Access Compliance Report

Public Rights-of-Way

Intersection ID: 10033070	Main Street: NORTH_COMMUNITY_HOUSE_RD	Cross Street: N/A	Location: SW
ADA ID: 5DB8D284B1B7	Ramp Type: Perp	Initial Pass/Fail: Fail	Overall Compliance: No
			Severity Score: 13.75

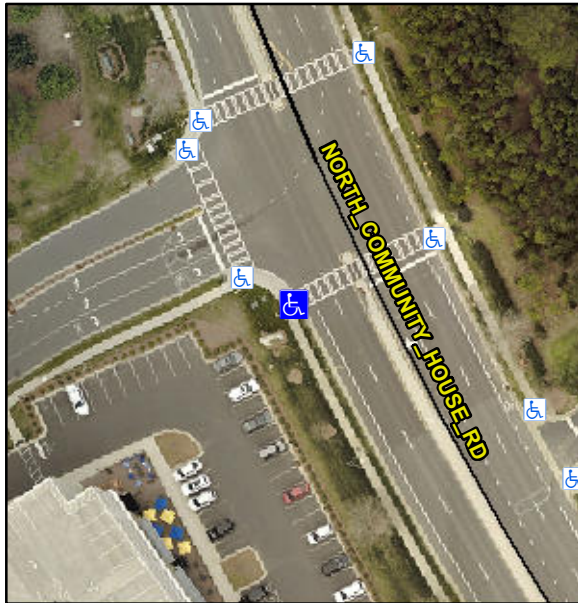
Not Found, R304.2.2

Compliance	Description	Data	Compliance	Description	Data
N/A	Ramp Length (in)	27.0	No	Ramp Slope (%)	10.4
Yes	Ramp Width (in)	48.0	Yes	Ramp XSlope (%)	2.7
N/A	Flare Type LT	N/A	N/A	Flare Type RT	N/A
N/A	Flare Slope LT (%)	N/A	N/A	Flare Slope RT (%)	N/A
N/A	Flare Traversable LT?	N/A	N/A	Flare Traversable RT?	N/A
N/A	Landing Length (in)	N/A	N/A	DWS Provided?	N/A
N/A	Landing Width (in)	N/A	N/A	DWS Contrast?	N/A
N/A	Landing Slope (%)	N/A	N/A	DWS Length (in)	N/A
N/A	Landing X Slope (%)	N/A	N/A	DWS Full Width?	N/A
N/A	Landing Curb? (Y/N)	N/A	N/A	DWS Offset (in)	N/A
N/A	Shared Landing?	N/A			
N/A	Gutter Ponding?	N/A	N/A	Gutter Slope (%)	N/A
N/A	Gutter Lip Ht (in)	N/A	N/A	Gutter X Slope (%)	N/A
N/A	Painted X Walk1?	Yes	N/A	Painted X Walk2?	N/A
	X Walk 1 Direction	To NE		X Walk 2 Direction	N/A
N/A	X Walk 1 Width (in)	111.5	N/A	X Walk 2 Width (in)	N/A
	X Walk 1 Slope (%)	2.1		X Walk 2 Slope (%)	N/A
	X Walk 1 X Slope (%)	3.2		X Walk 2 X Slope (%)	N/A

Remove & Replace Entire Ramp.
